The wide trench condition and its effect on the loads imposed on rigid underground conduits

N. W. B. Clarke, M.Eng., M.I.C.E., A.M.I.W.E.

Mr A. G. I. Shayo (Messrs J. D. and D. M. Watson) submitted the following comments.

FIG. 11

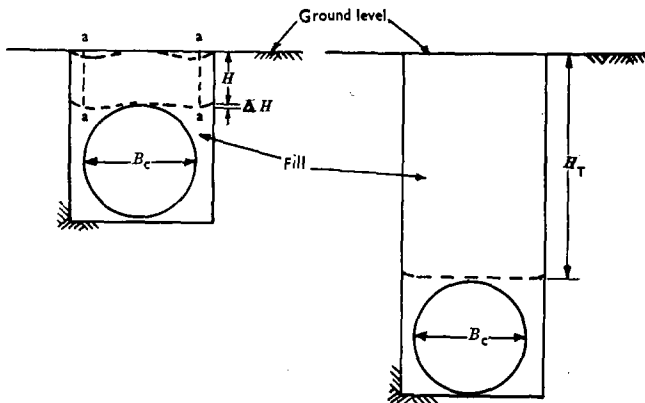
43. In a shallow trench the slice of fill on top of the pipe behaved like a flexible beam, propped in the middle by the pipe and supported at the edges by the frictional forces on the trench sides. This slice of fill deflected as shown by the dotted lines in Fig. 11. When the slice was thin, the deflexion would be sufficient to cause rupture along the vertical planes a-a. The external prisms then tended to drag down the internal prism by frictional shear forces. This constituted wide trench conditions of loading.

FIG. 12

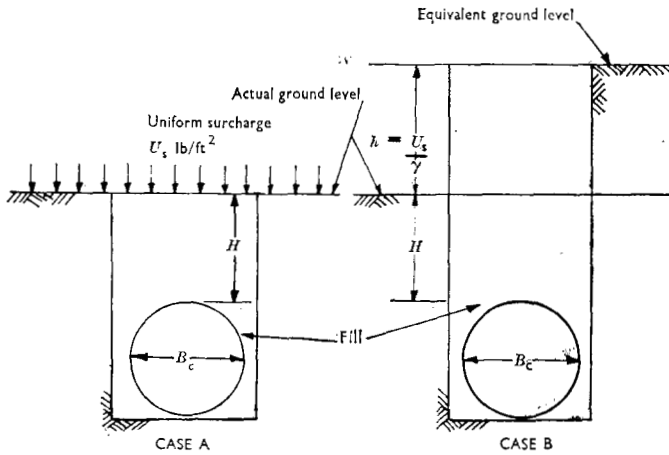
49. The Author considered the two cases shown in Fig. 12 as being identical for the purpose of working out the combined fill/uniform surcharge load coming on the pipe. Assuming 'complete trench conditions', however, which would hold for shallow trenches, and working out the equations for the combined loads from fundamental principles, the following equations were derived:*

58. With reference to §§ 49–52, in general design, where the nature and position of uniformly distributed surcharges are not predetermined, it was considered advisable to assume the 'worst' conditions, i.e. for 'wide' trench conditions, that the surcharge itself developed unfavourable friction (with $K\mu=0.19$); and for 'narrow' trench conditions, that the surcharge itself was frictionless. In § 49, Mr Shayo's Case A for the wide trench condition assumed that the surcharge was frictionless. This explained the difference in the curves A and B in Fig. 13, since Case B assumed a frictional surcharge in the 'complete' condition.

FIG. 13

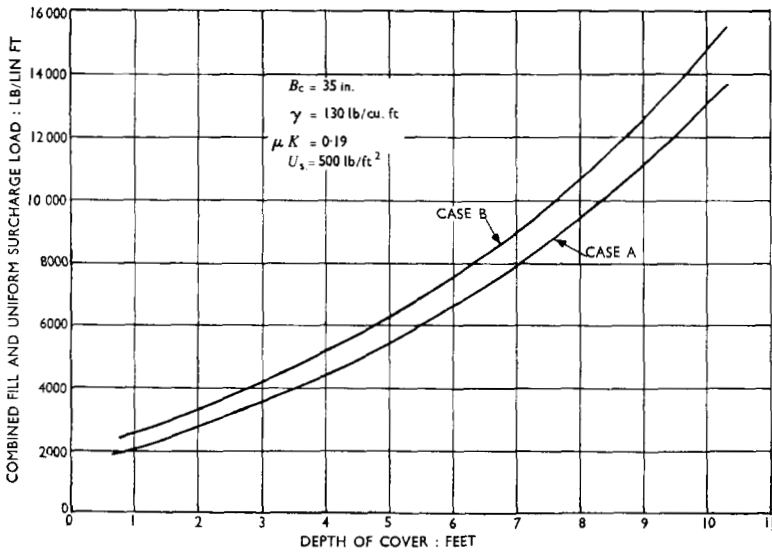
Fig. 13 showed a comparison of the loads calculated from the two equations.

50. The method of substituting a column of fill of height $h = U_s/\gamma$ for the uniform surcharge over-estimated the combined load. By that method, friction, which in that case increased the load on the pipe, was assumed to act in the equivalent column; i.e. frictional shear forces were assumed to act over an area of a height $(H+h)$. In actual practice those forces acted over an area of a height H only. Case A restricted the frictional forces to the actual height H and also took into account the fact that at ground level the vertical pressure was $U_s/\text{sq. ft}$ and adjusted the lateral pressures and frictional shear forces accordingly.
